Ashton Village Center

SECTOR PLAN

Ashton Village Center Sector Plan

Worksession #1

Porter Road R-90 Zone

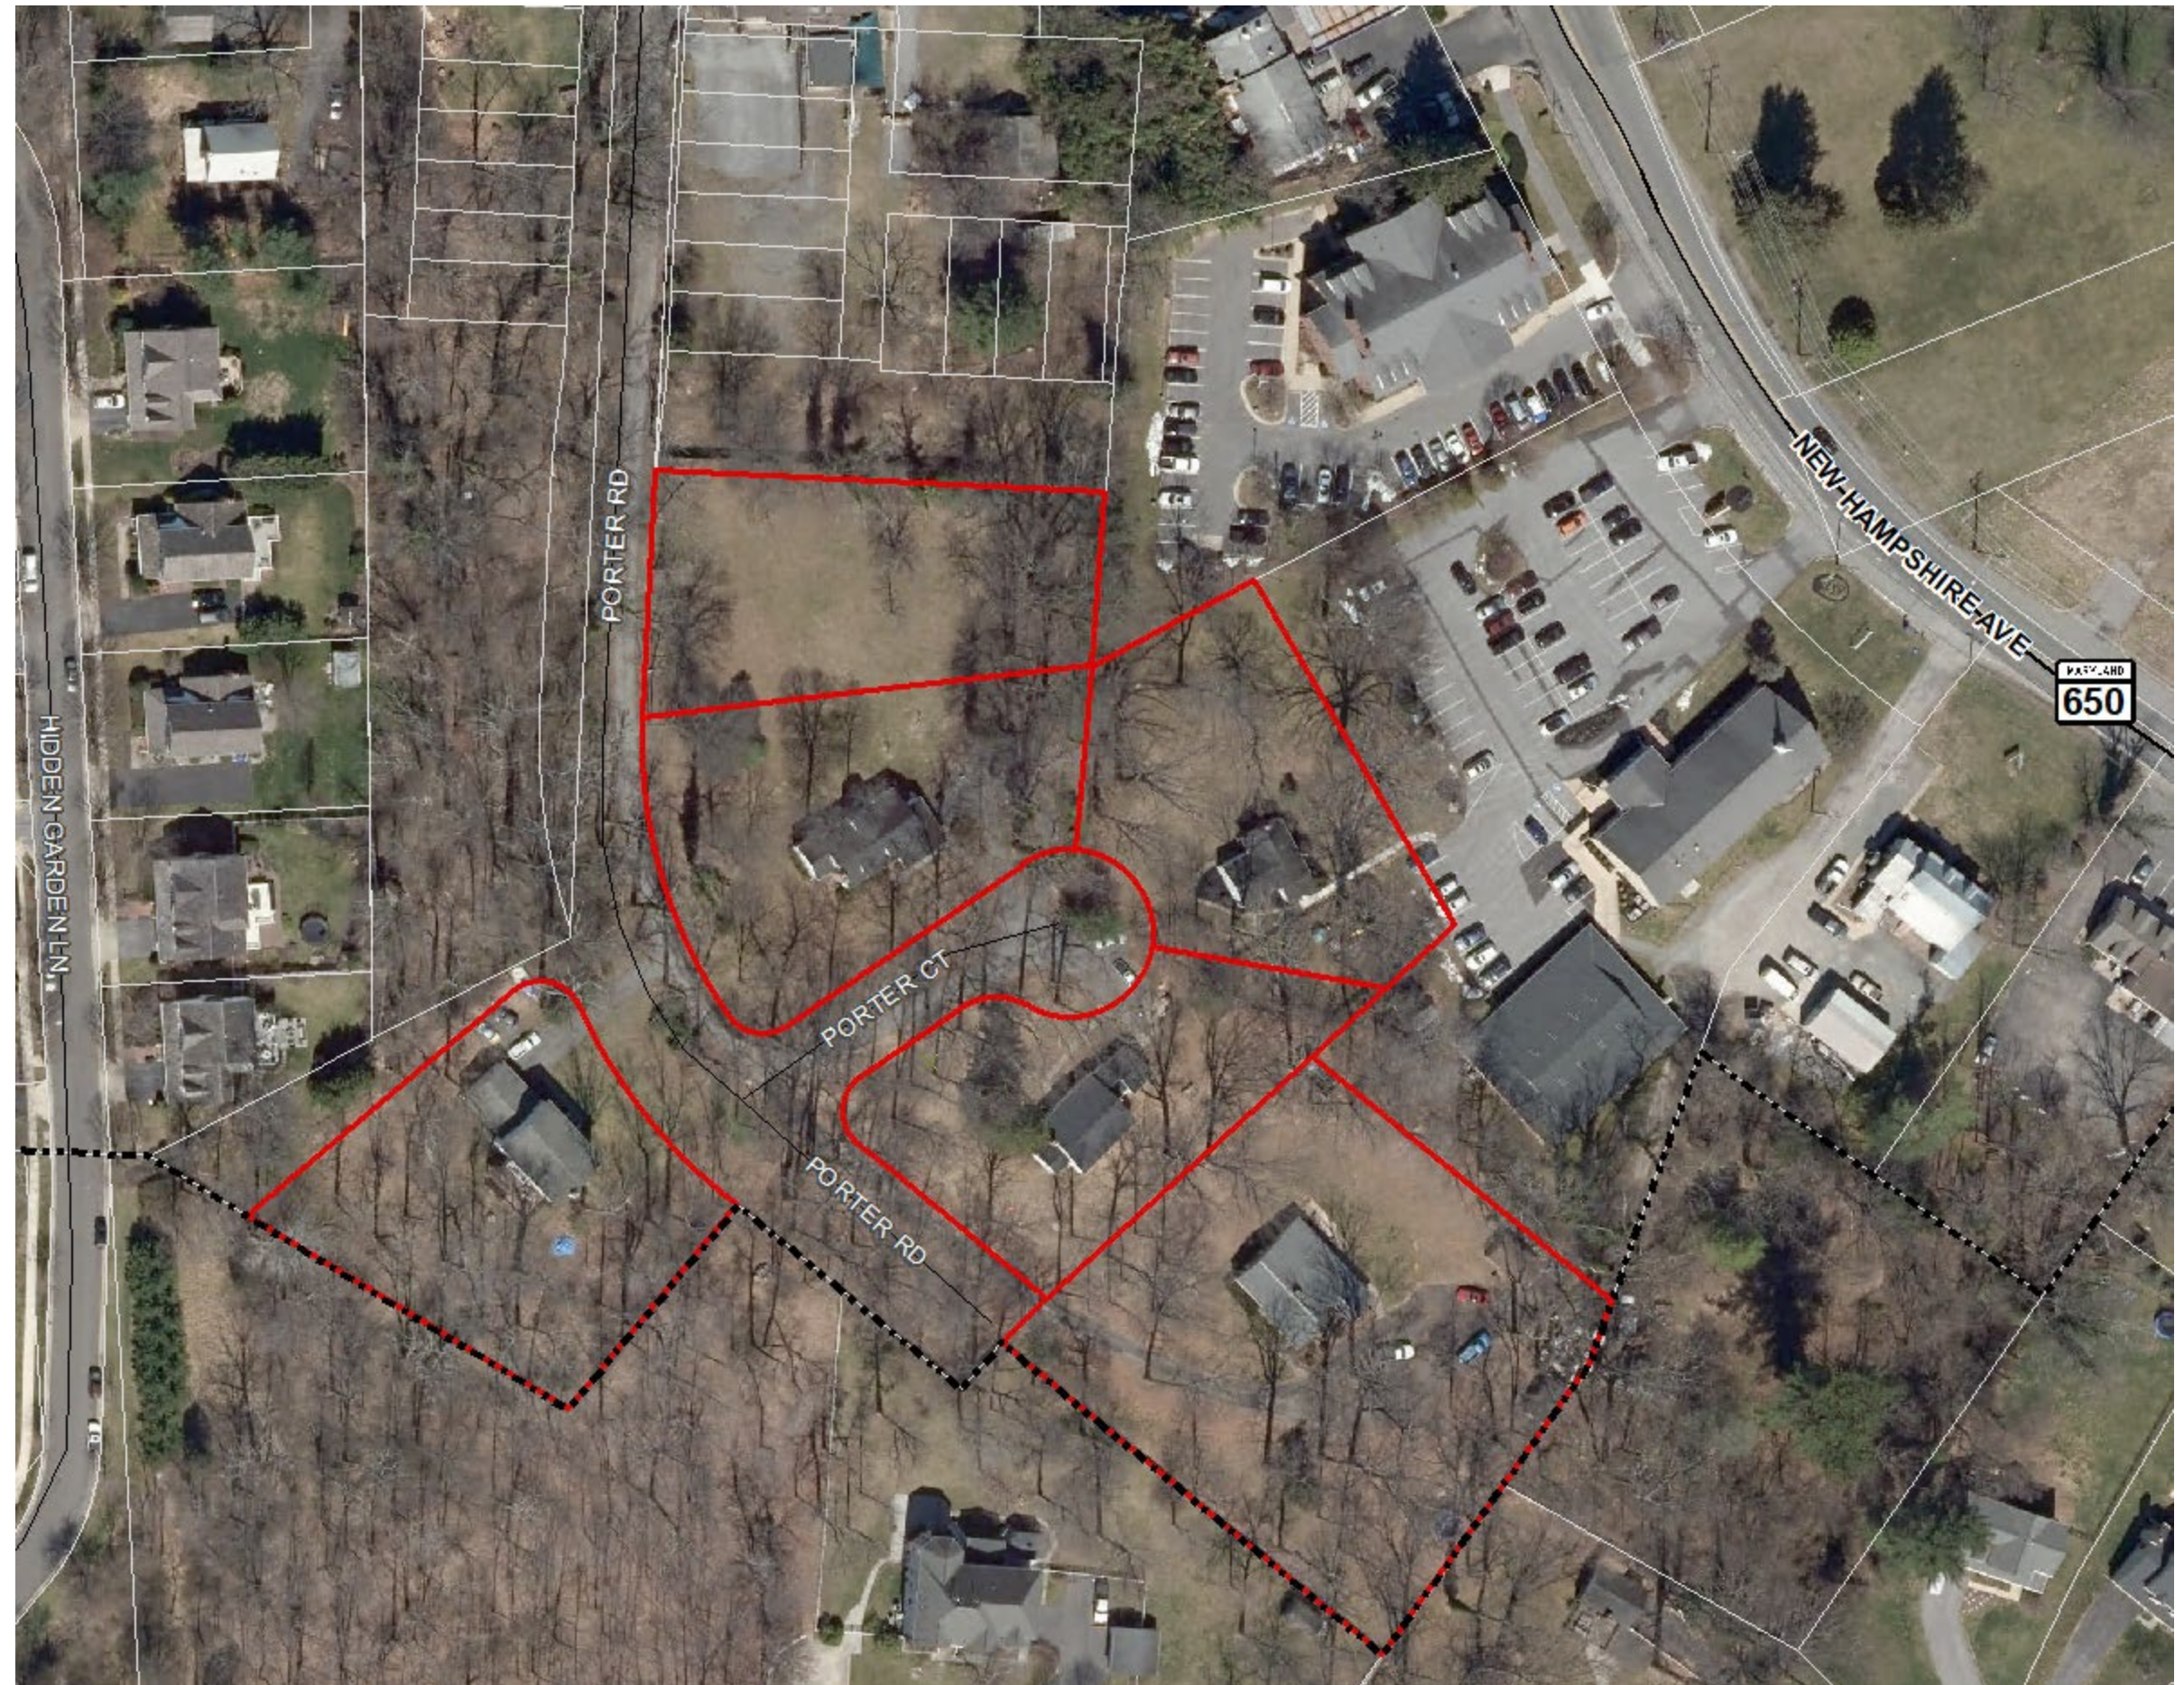
- The Ashton Market townhouse development will expand south down Porter Road
- The Ashton Market development will improve the site

- Retain the R-90 zone for these properties.

Cloverly Property

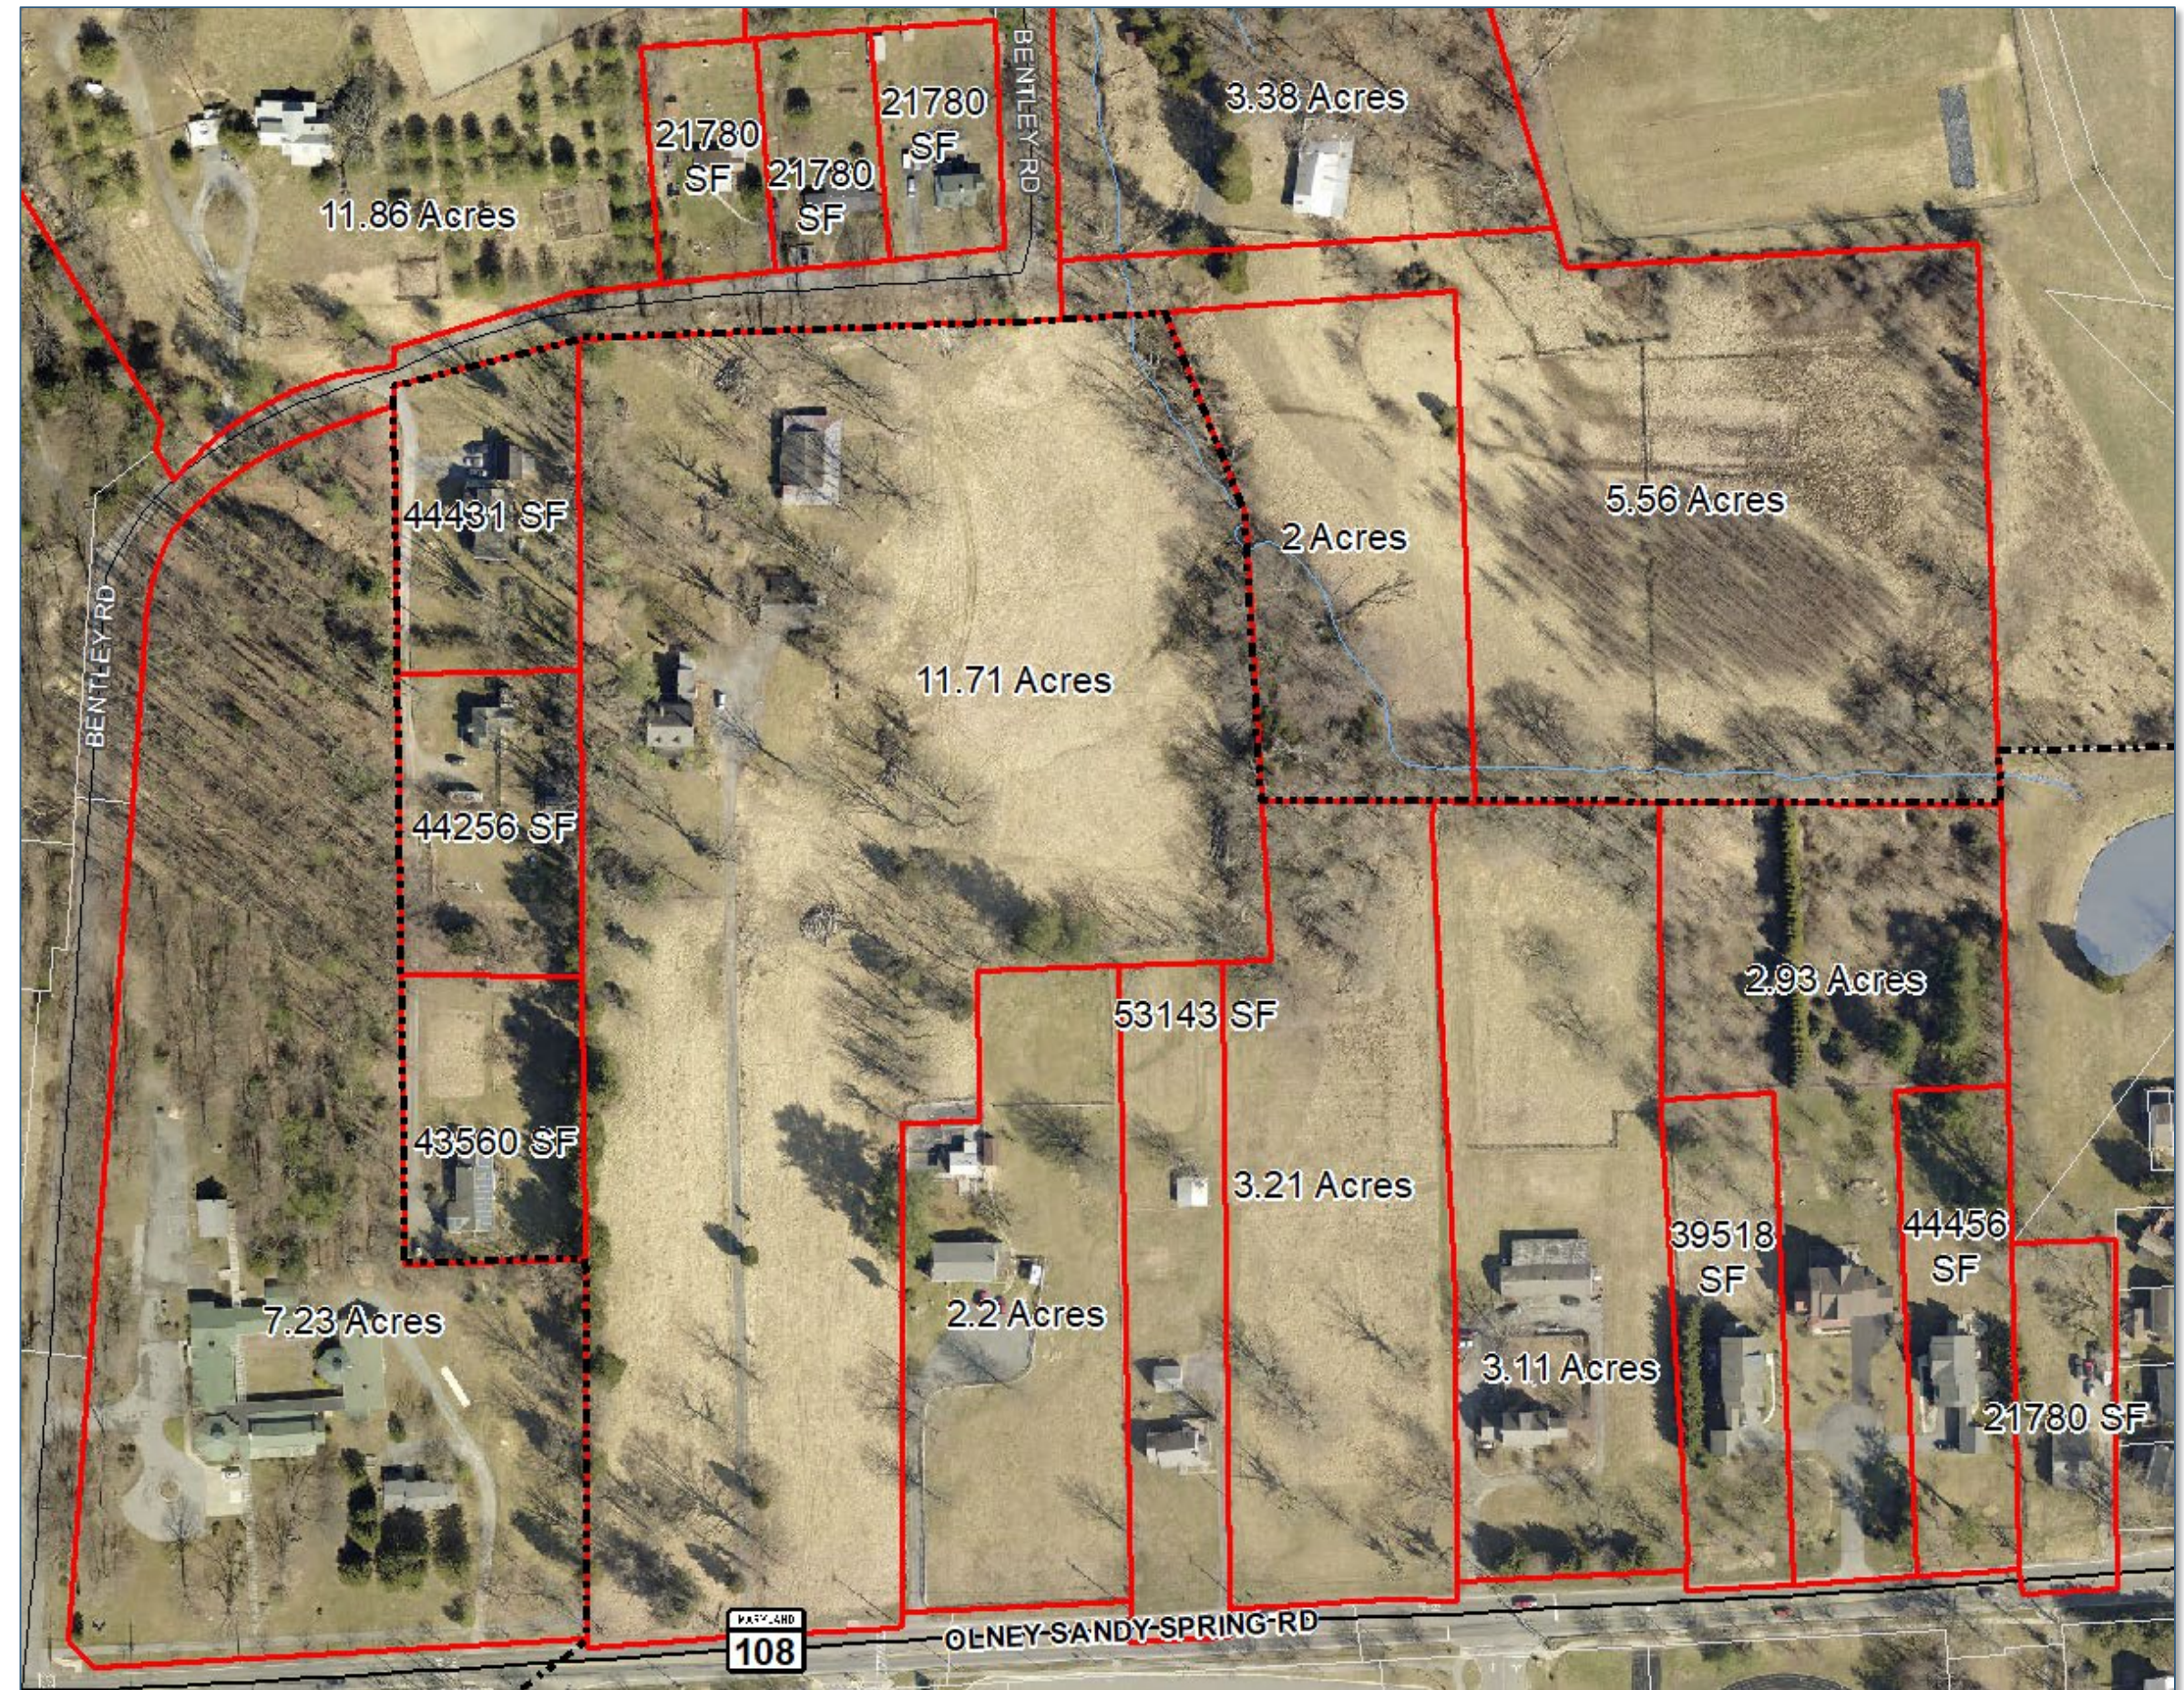
- The owners have expressed deep concern over the zoning changes and historic designation that have been enacted over the past 30 years

- Retain the RC zone
